This page lists the known errors on the gm5x5x5 PCBs. There are no known issues with the bulk order run (white PCBs), the following information is valid **only** for the prototype run (green PCBs).

Bulk Order #1 (white PCB, rev 1.0)

#1 MIDI IO pins

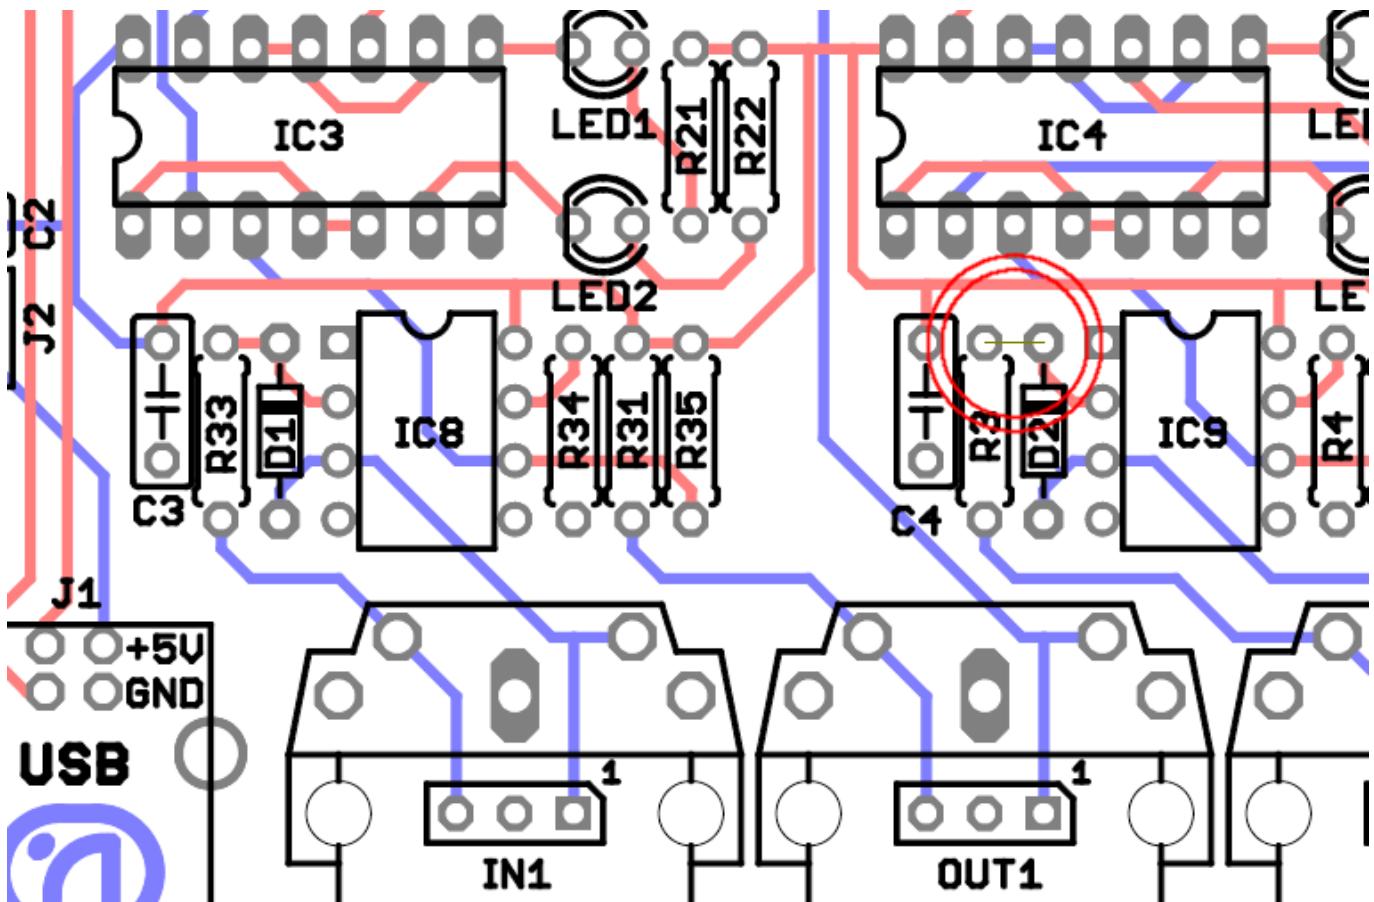
Problem: The MIDI IO pins of the midi sockets (Pin 4 + 5) are switched.

Solution: Either (1) use the pin-headers if you use sockets that are not mounted on the PCB or (2) break the traces to pins 4 + 5 of the sockets and solder wires to them or (3) solder the midi sockets on the other side of the PCB.
